SEWAGE DISPOSAL SYSTEM

MARYLAND STATE DEPARTMENT OF HEALTH

SUBDIVISION Sheets Property ROAD 13950 Monticello Drive LOT _____

PROPERTY OWNER Thomas E. Sheets

A 36443

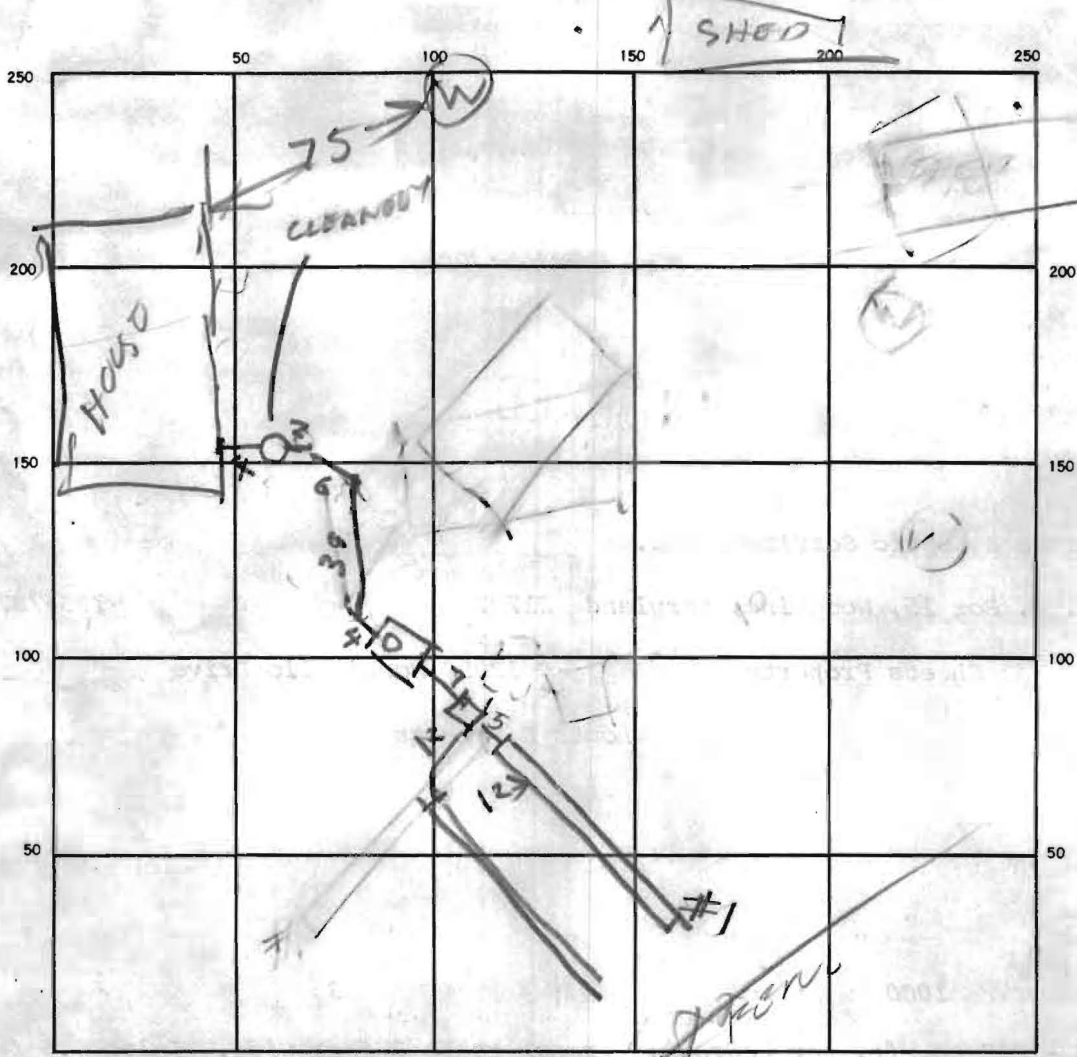
REMARKS 7/8/87 - TRENCH #1 OK & LOCATION OK ADD STONE
TO TRENCH #1 DIG TRENCH #2
7/8/87 - TRENCH #2 DUG TRENCH #1 OK COVER TANK
ADD STONE TO TRENCH #2 RN
7/8/87 400 - STONE ADDED TO TRENCH #2
